**P01:**  
Changes made to previous revision to incorporate  
Community room G.17 with relocated offices to room  
G.24.

ISSUE	DATE	DRAWN	CHECKED	DESCRIPTION
DRAWING TITLE		GA PROPOSED DEMOLITIONS AND STRIP OUT NORTH-EAST LW.03 - ELEVATIONS		
DRAWING NO.		CTH-PUR-MP-ZZ-DR-A-91106		
REVISION		P01		
SIZE & SCALE		A1L	1:200	
DRAWING STATUS		S4 - Planning

CLIENT	Lendlease	
PROJECT	Camden Town Hall	
JOB NUMBER	238664

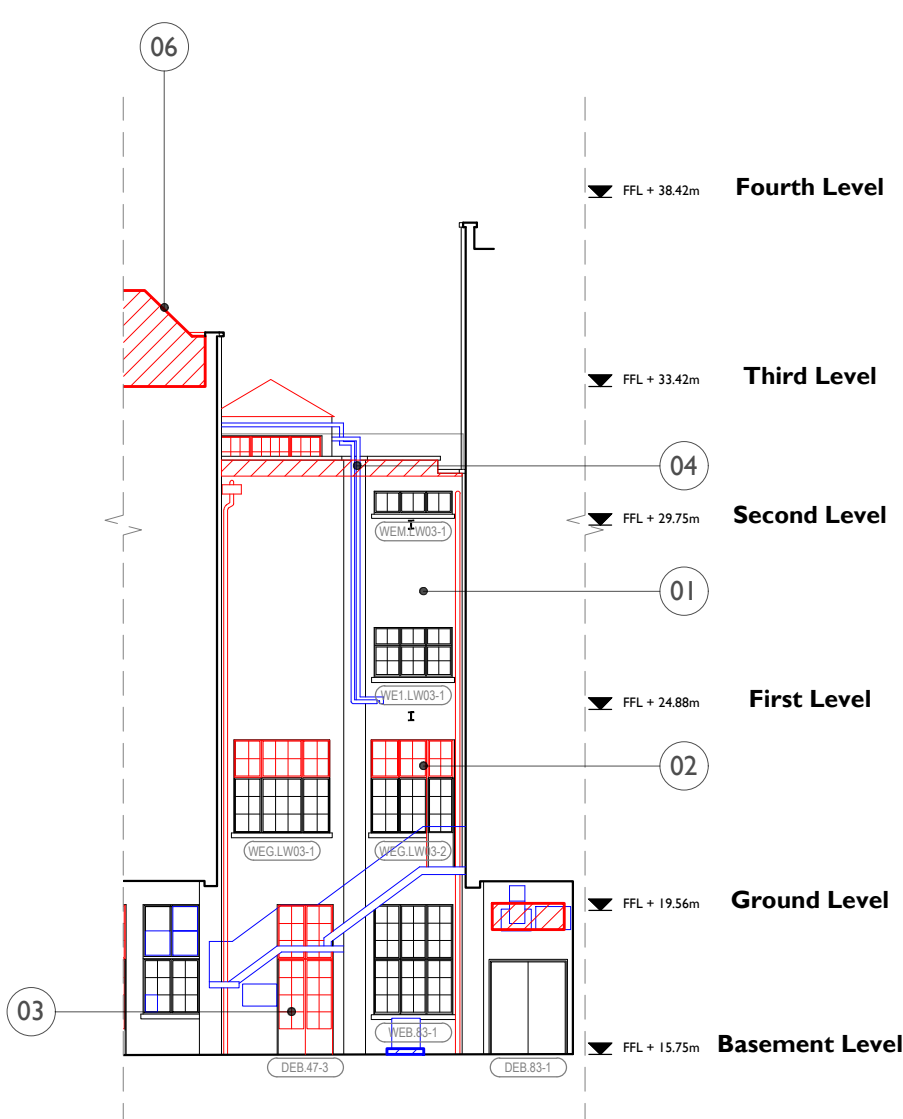
Revision: Community Space  
600mm x 500mm Mechanical  
plant intake louvre introduced  
to facade
